593 & 601-603 Laurier Avenue West

UDRP REPORT
Official Plan and Zoning By-law Amendment Applications
June 15, 2025

URBAN DESIGN BRIEF

601 LAURIER AVENUE

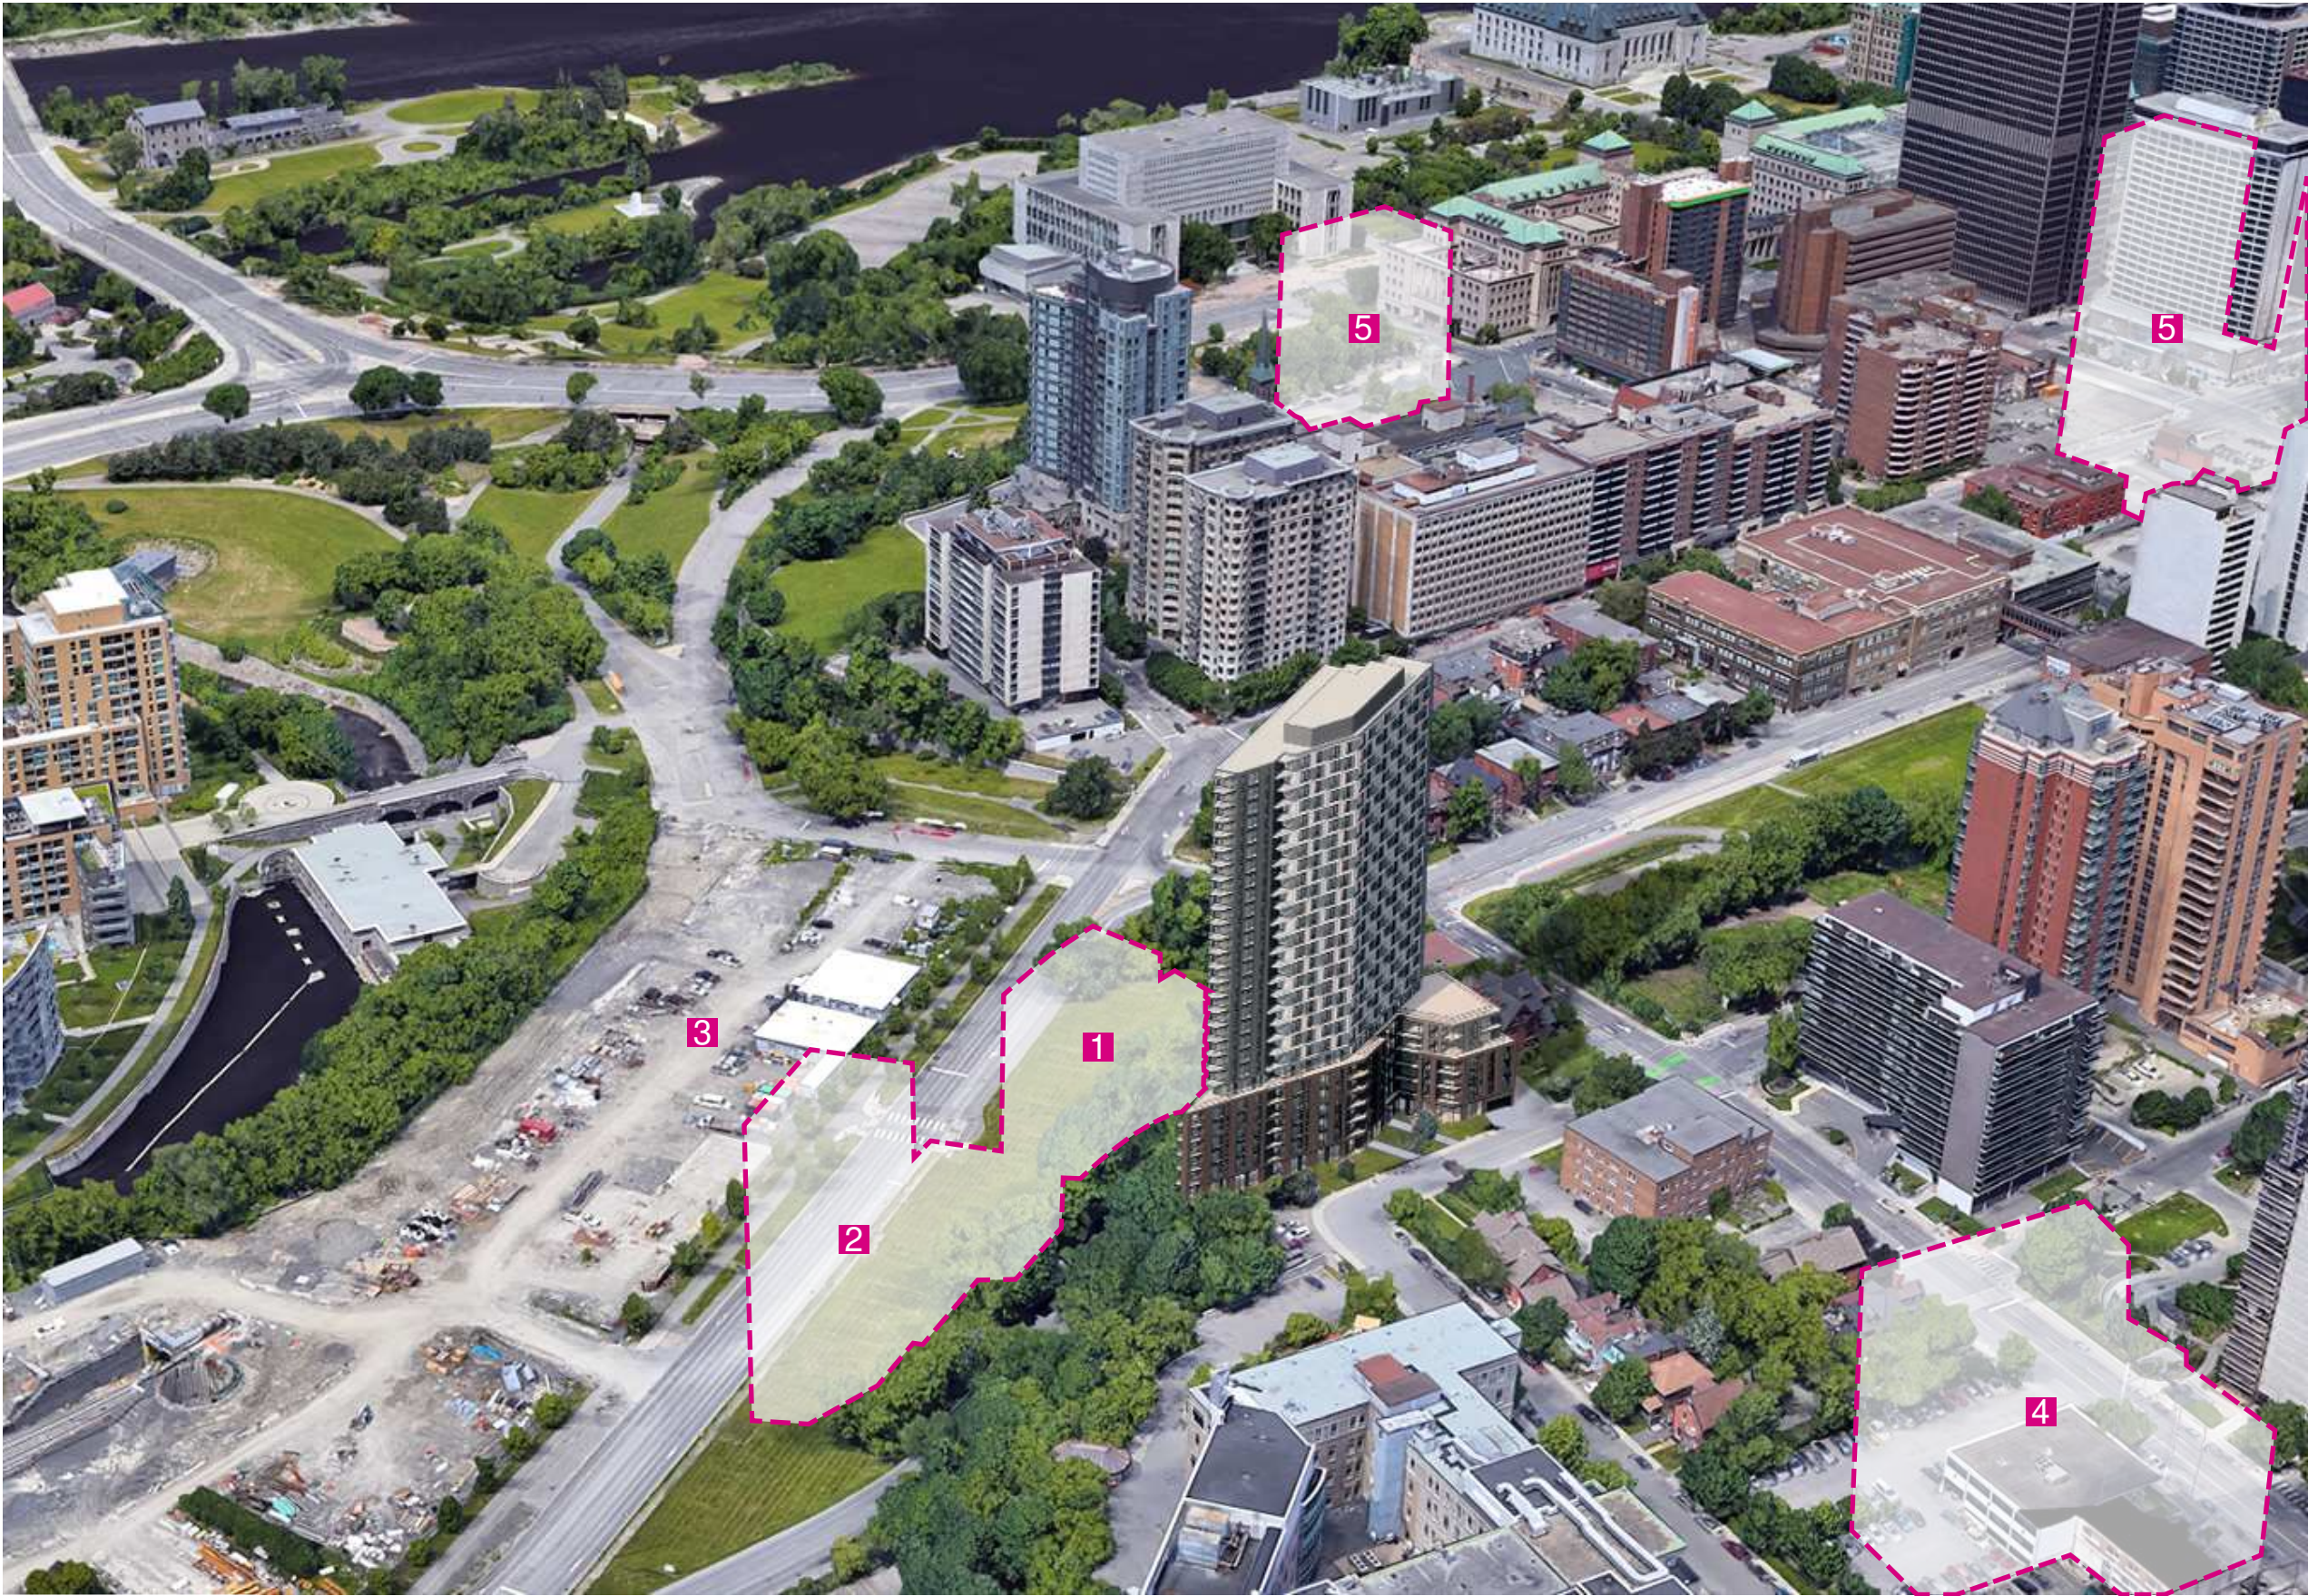
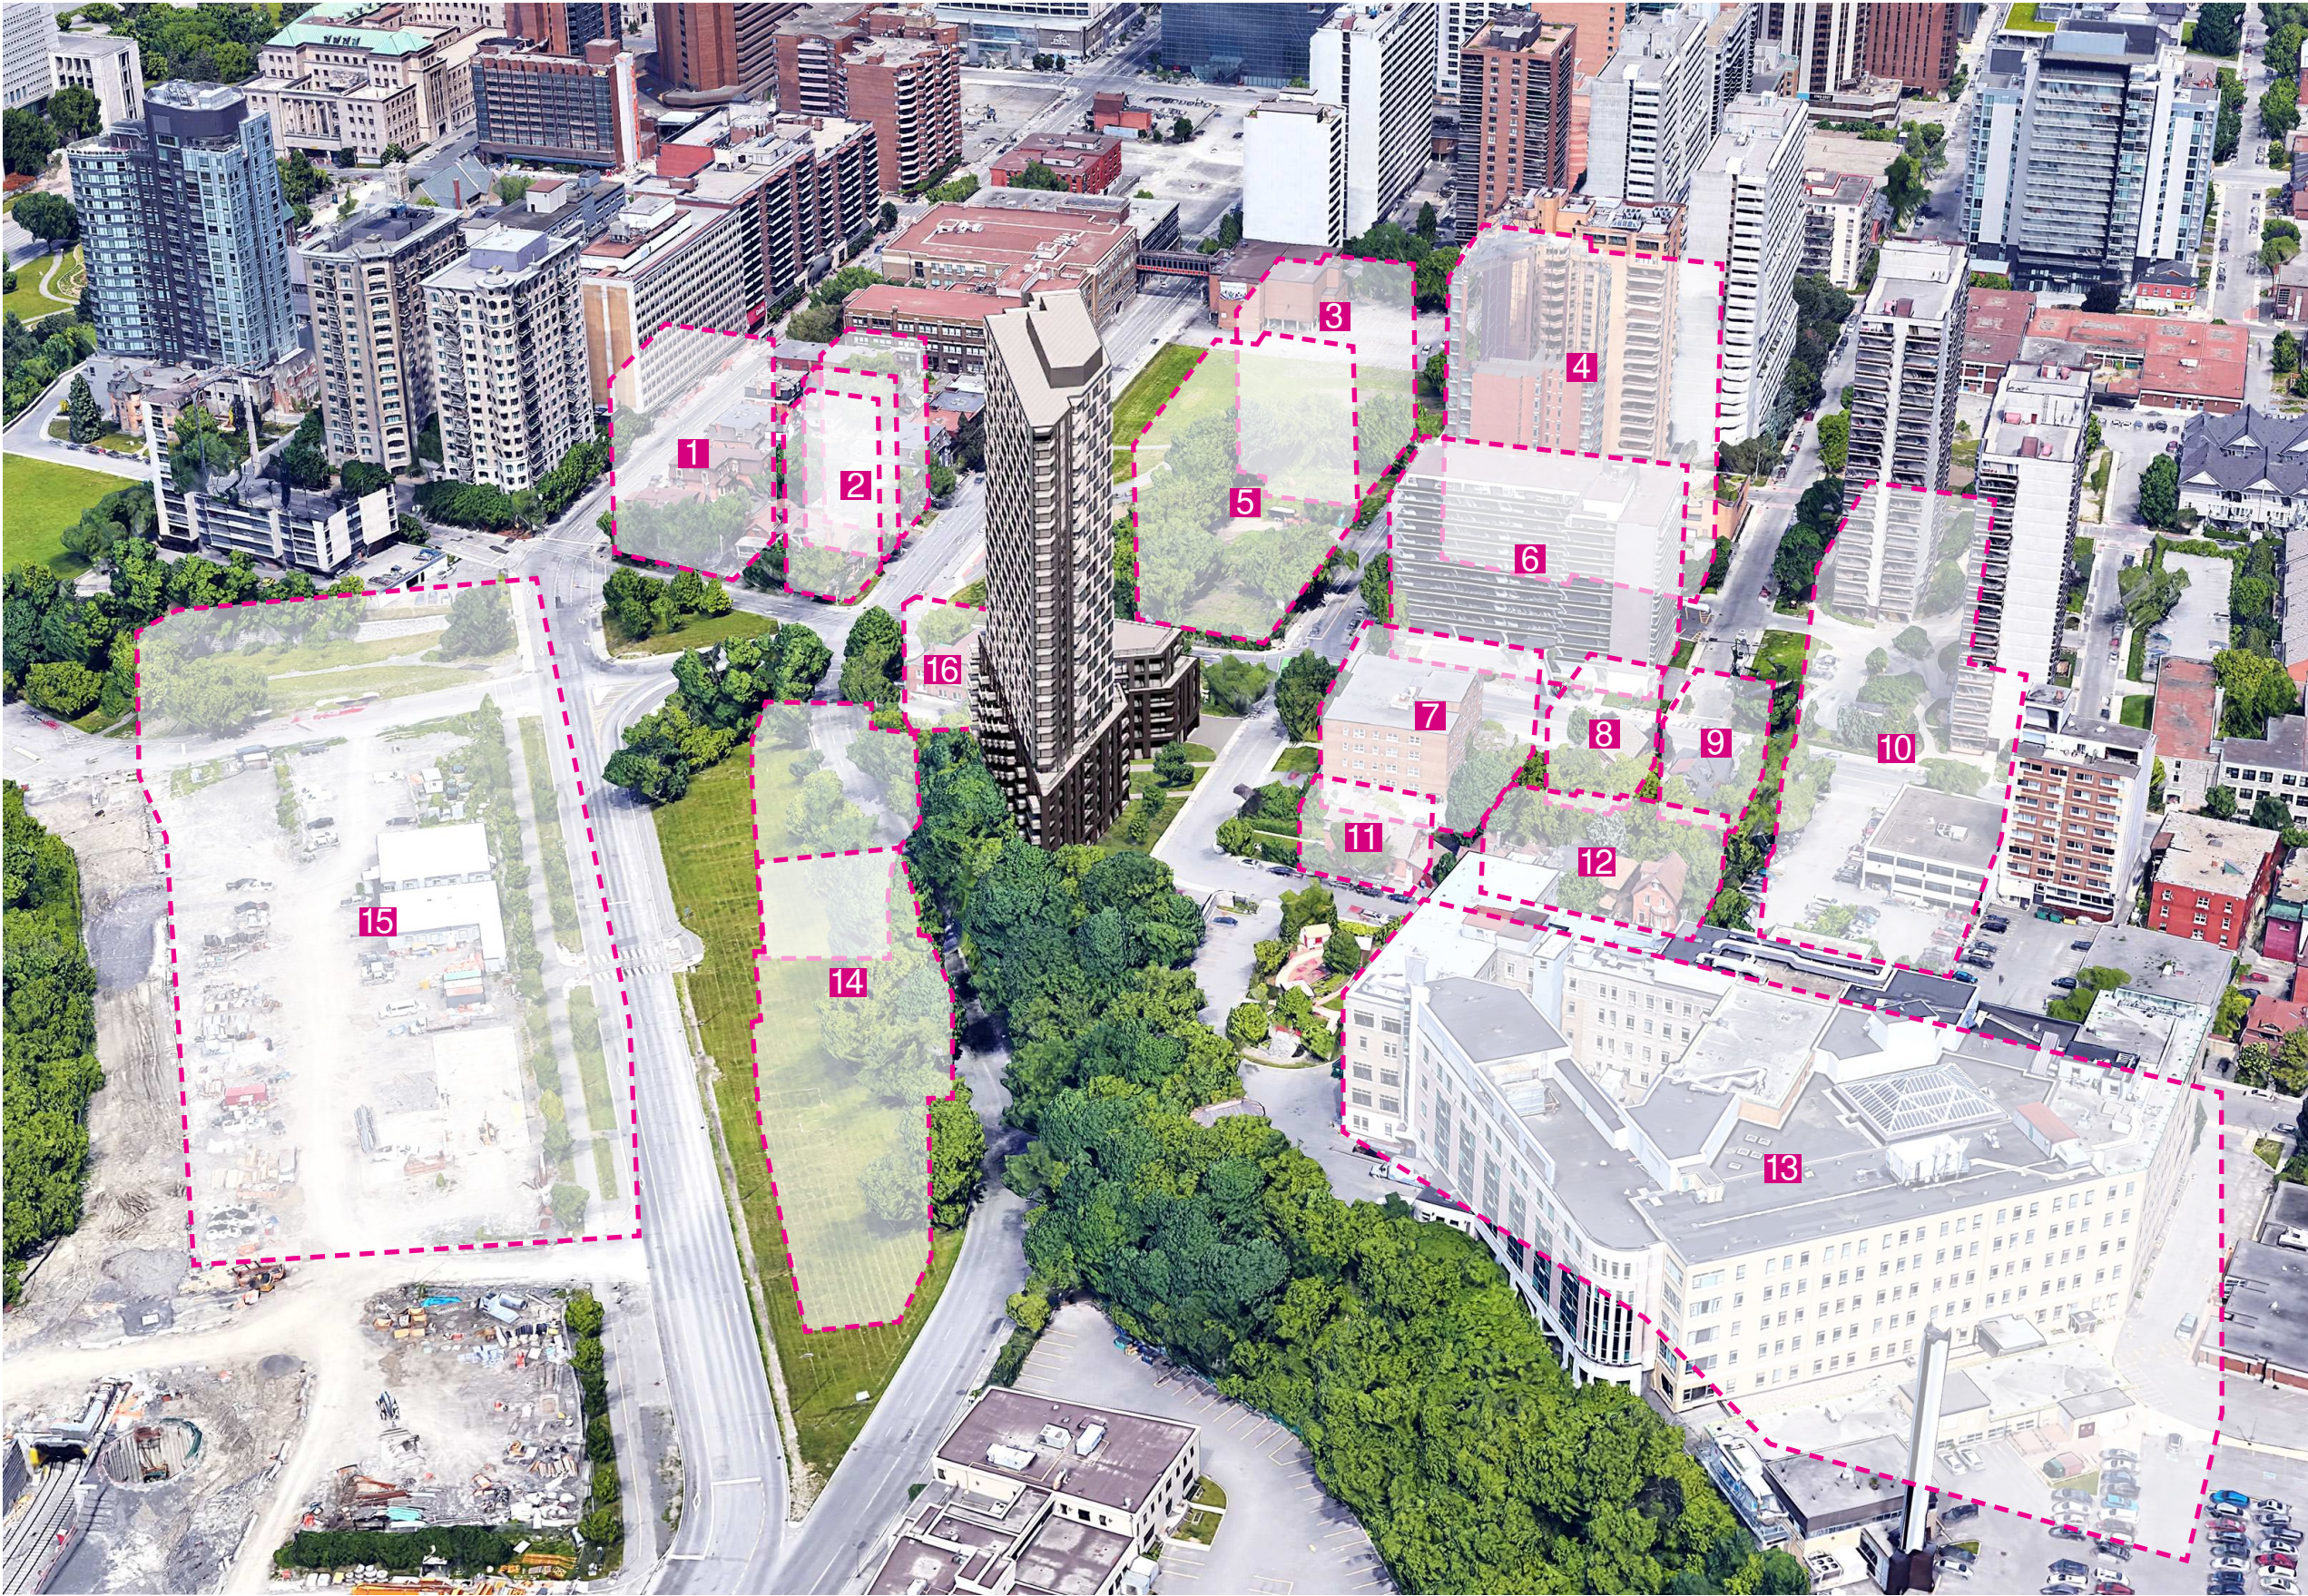
We recommend providing massing of the project and its context to better understand the future relationship to the existing context of the surrounding properties and their planned context. Be sure to include the properties down the escarpment and along Cambridge, Laurier, Bronson and where Slater has been removed.

We have provided material illustrating the massing of the project and its context, showing the relationships with the escarpment and surrounding properties. This includes properties down the escarpment and along Cambridge, Laurier, Bronson, and the area where Slater has been removed. These visuals help to better understand the future relationship to the existing and planned context of the surrounding area.

601 LAURIER AVENUE TRANSITION / ANGULAR PLANE STUDY

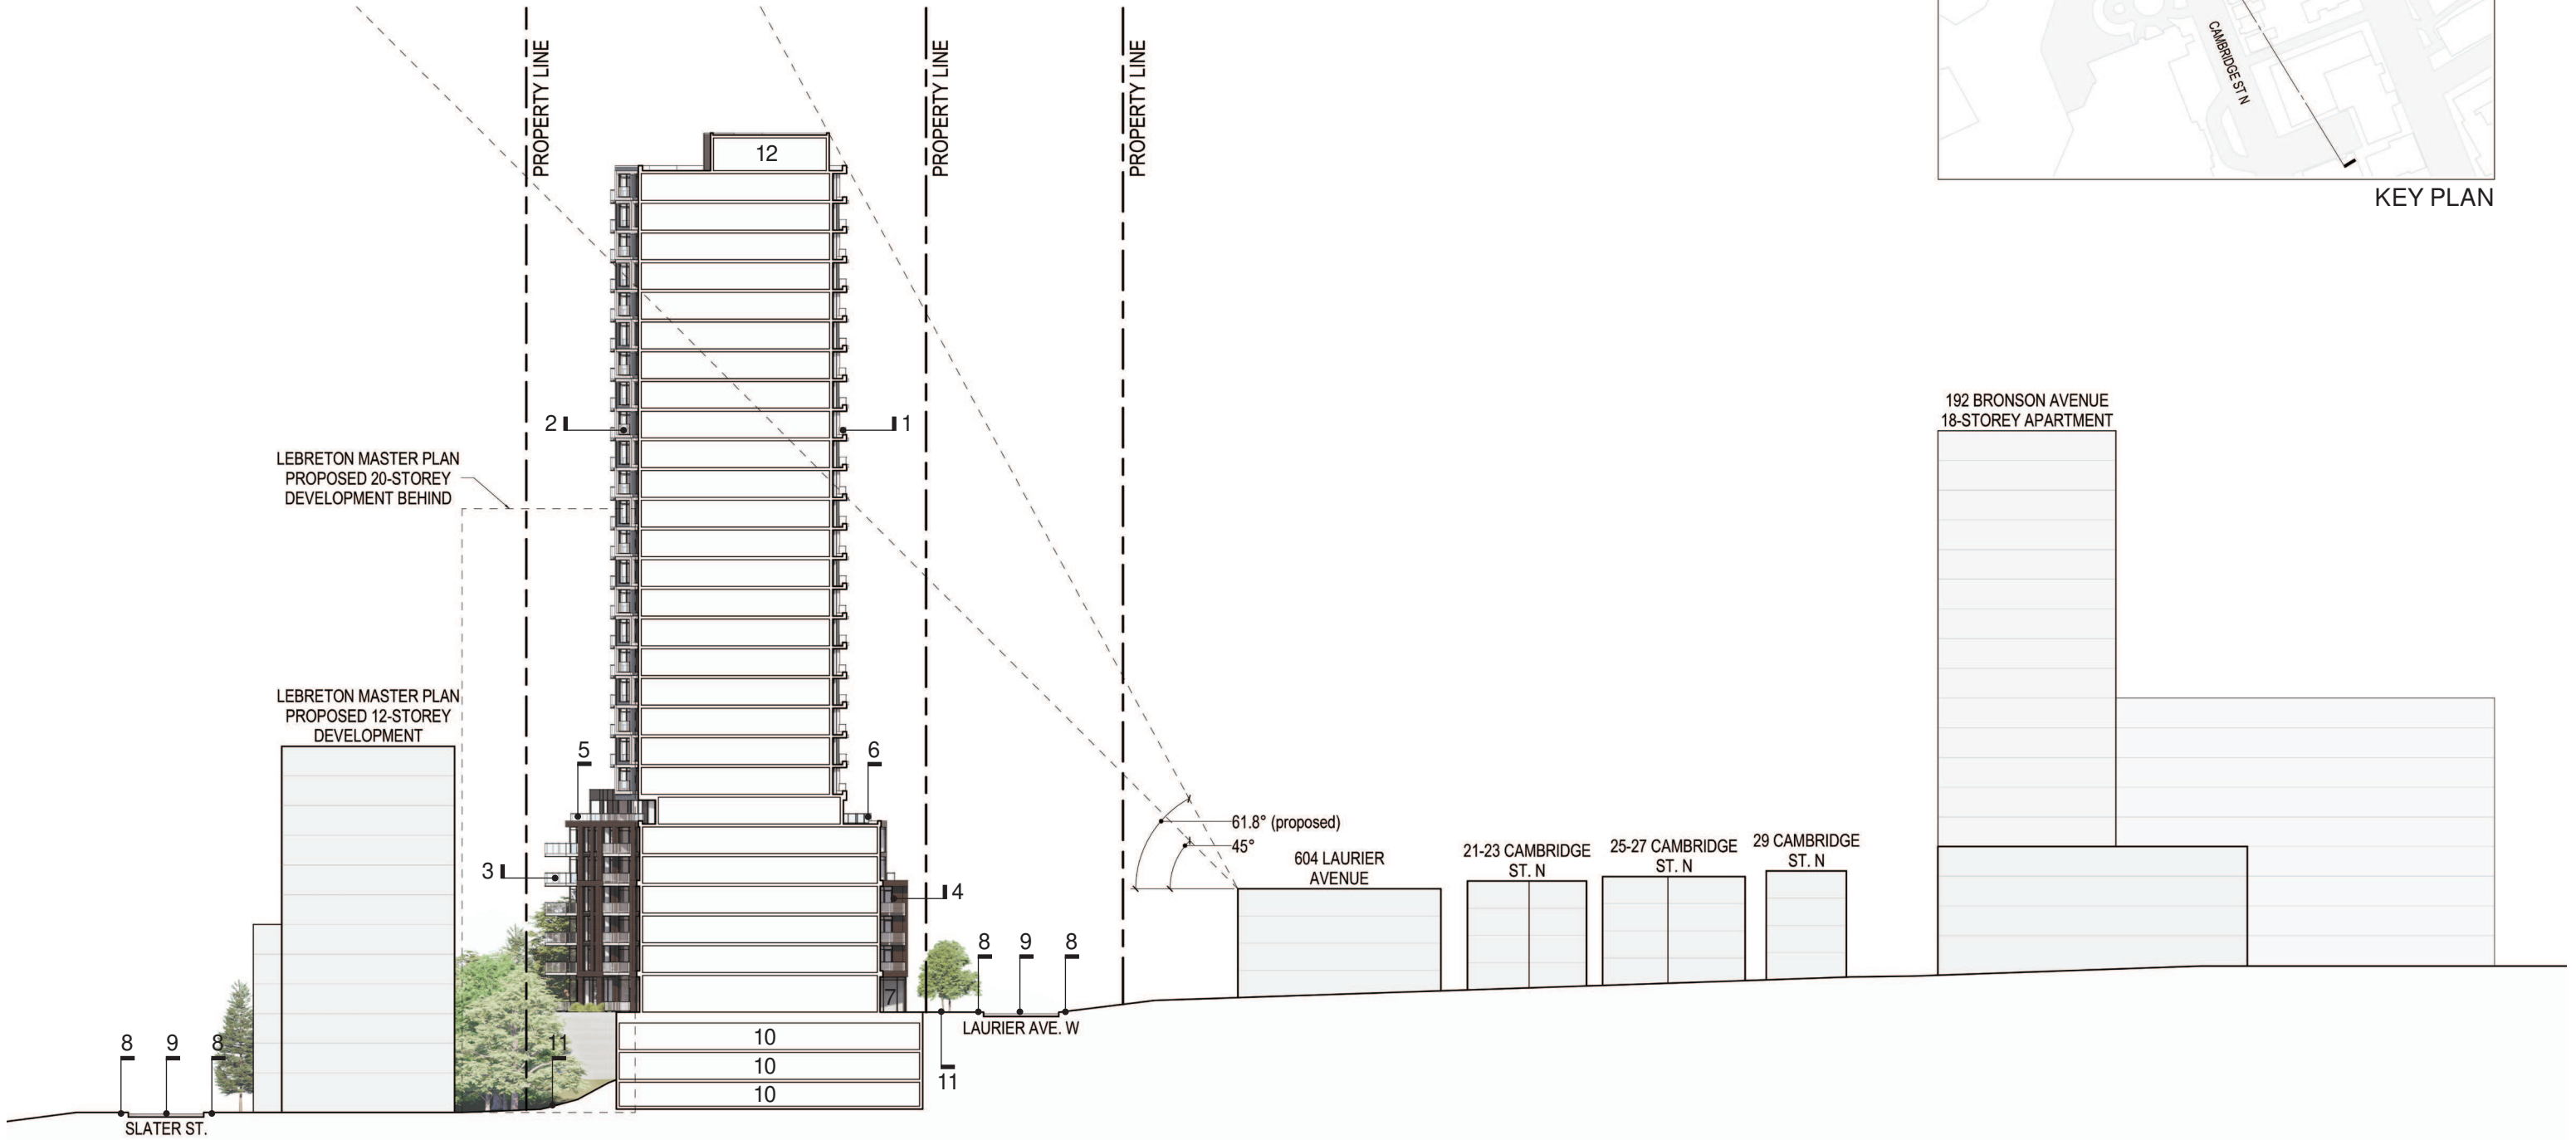
Height: There would be two overlapping tools to determine the best approach to analysing appropriate height being the NCC Parliamentary view shed analysis, extrapolated over the site, and a 45-degree angular plane drawn from the residential properties to the south on Cambridge. We recommend illustrating both and providing a rationale for the approach preferred.

We have provided graphic material illustrating the building’s relationship with the neighboring buildings, including the 45-degree angular plane calculated from the existing buildings along Cambridge to the south. Our subject property falls outside the boundaries of the NCC Parliamentary view sheds, so this analysis was not considered.
